SERVICE BULLETIN

SB-09-009

Vortex Return Air Bulkhead

Carrier Vector/FG Vortex Heat Shield Tape Installation

Diagram A

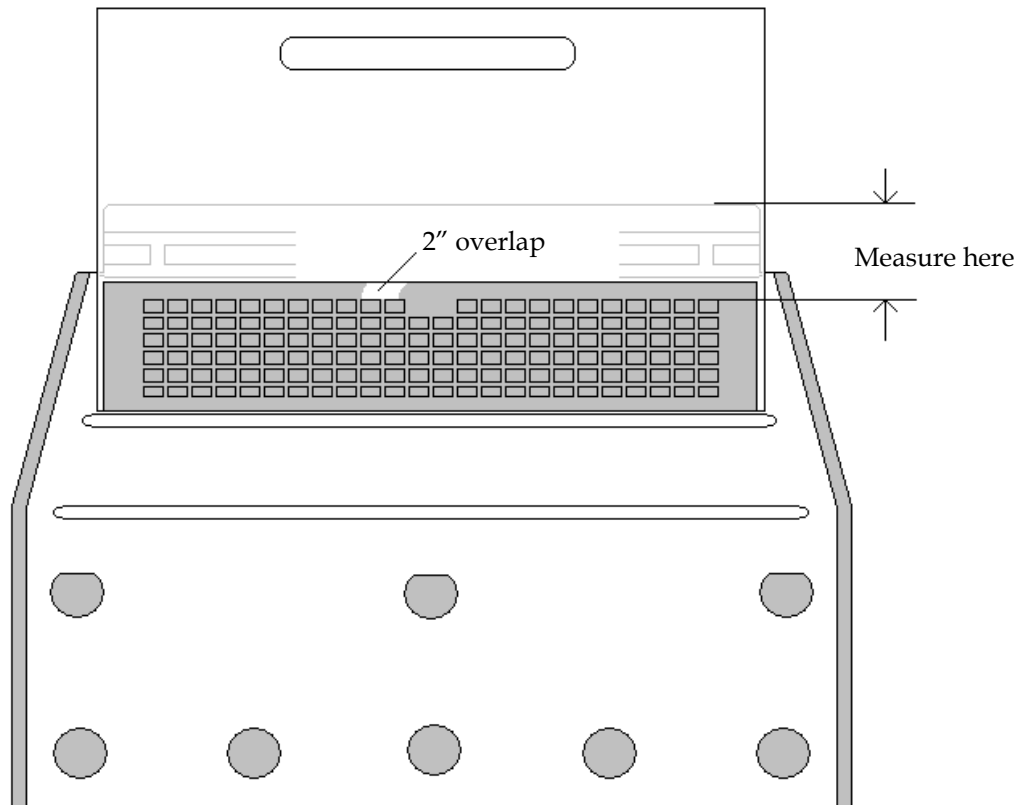
As Protection, FG Products recommends radiant heat-reflecting tape to reduce the temperature on the back of Vortex bulkheads at the location of the face plate vent of the Vector Refrigeration Unit. See Below.

- 2) Remove the bulkhead and lay it flat on the floor of the trailer.
- 3) Measure from the mark on the Vector unit down to the top of the face plate vent. The reflective tape will be installed with a two-inch overlap (diagram A) above this measurement.
- 4) Thoroughly dry and wipe clean the back surface of the bulkhead in the area the tape will be applied. The bulkhead **MUST** be dried completely and should be near room temperature for application of the reflective tape. It is not necessary to wash the bulkhead.
- 5) Cut a 60 Inch piece of tape from the roll.
- 6) Peel back several inches of the tape backing and stick the reflective tape to the bulkhead overlapping the measured mark (step 3) by 2 inches.

- 1) With bulkhead installed, note the location of the Vector face plate vent on bulkhead. You can mark the top of the bulkhead on the Vector unit and measure down to the vent once the bulkhead is removed.

7) Continue peeling the backing and adhering the tape to the bulkhead. Smooth out any bubbles in the tape for a secure bond. Wrinkles may happen and will not interfere with the performance of the reflective tape.

8) Reinstall the bulkhead on the front wall.
